SERVICE BULLETIN CHANGE NOTICE

S.B. No. A320-21-1007

TITLE: AIR CONDITIONING - AIR GENERATION - MODIFY AIR CONDITIONING PACK

SERVICE BULLETIN NO: A320-21-1007
CHANGE NOTICE NO: 0A

Replacement of Hoses and Pipe with
Hoses and Elbows to the Anti-icing Valves
Figure 1

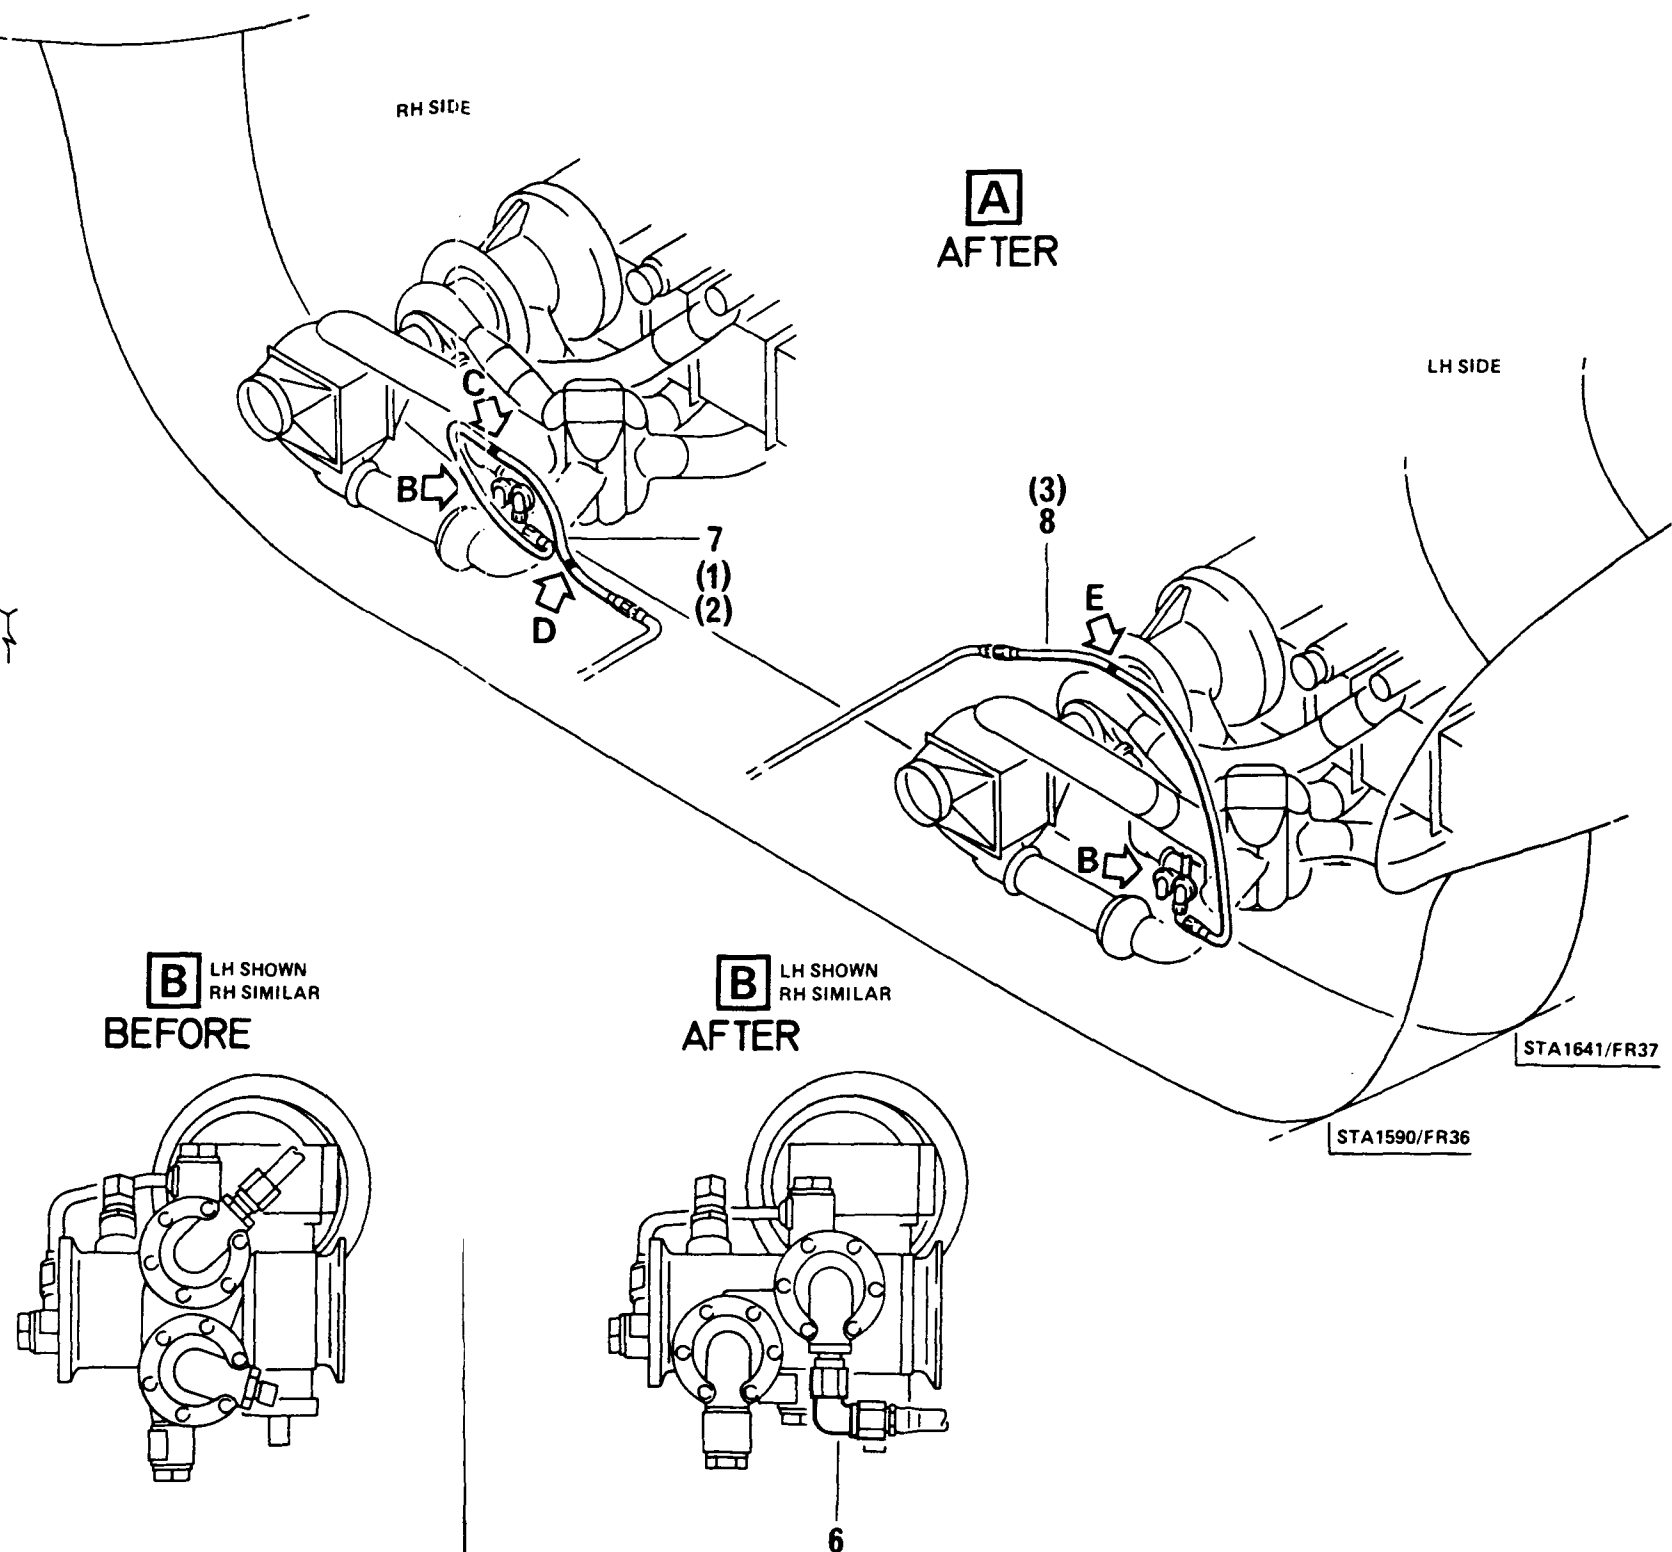
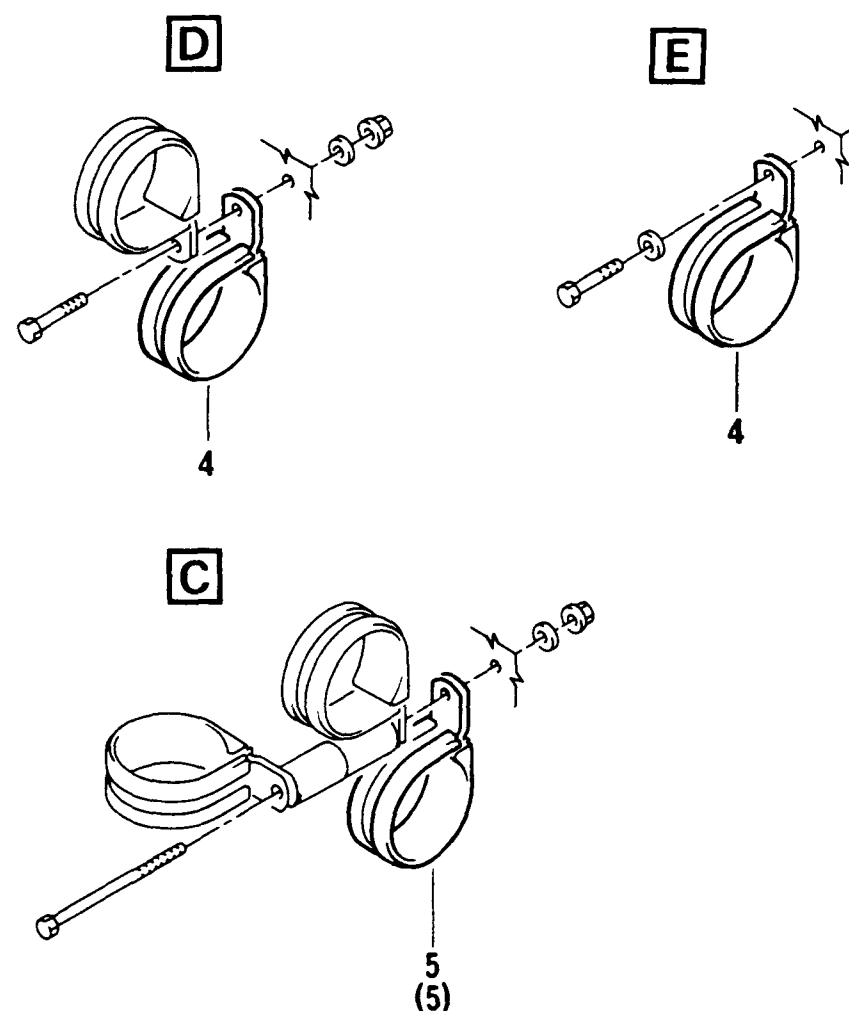
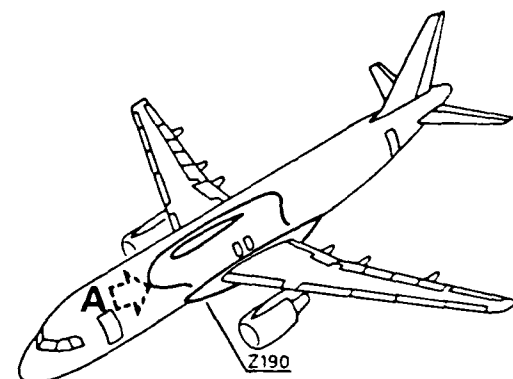
- (12) Remove hoses and pipe items (1), (2) and (3) between the anti-icing valves LH and RH and existing pipes (Refer to Figure 1).
 - (a) Remove the clamps, items 7 and (5) from hoses, item (2) and (3) and pipe, item (1).
 - (a1) Retain the hardware and the clamps, item 4, discard the clamp, item (5).
 - (b) Remove and discard following parts:
 - 2 hoses, item (2) and (3)
 - 1 pipe, item (1)
- (13) Replace pipe assemblies which are specified in the LIEBHERR ABG-SEMCA Service Bulletin No. 748A-21-01.
- (14) Install hoses items, 7 and 8 and elbows, item 6, to the anti-icing valves LH and RH and to the existing pipes (Refer to Figure 1).

- (a) Install to each anti-icing valve:
 - 1 elbow, NSA855120-6C, item 6.
- (b) Install to the elbow, item 6 of the RH anti-icing valve and to the existing pipe:
 - 1 hose 02157143703400, item 7.

- (c) Install to elbow, item 6 of the LH anti-icing valve and to the existing pipe:
1 hose D2157143703200, item 8.
- (d) Install the retained clamps, item 4, and 1 new clamp NSA5516-13NJ, item 5, to the new installed hoses, use the retained hardware.
- (15) Remove the pack outlet pneumatic sensors 10HM10 (11HM10), (Refer to AMM 21-61-19, P. Block 401).
- (16) Install the pack outlet pneumatic sensors 10HM10 (11HM10), which have a reduced setting as referred to in the LIEBHERR ABG-SEMCA Service Bulletin No. 767A-21-01. (Refer to AMM 21-61-19, P. Block 401).
- (17) Reidentify air conditioning pack as per Para. 3.C.
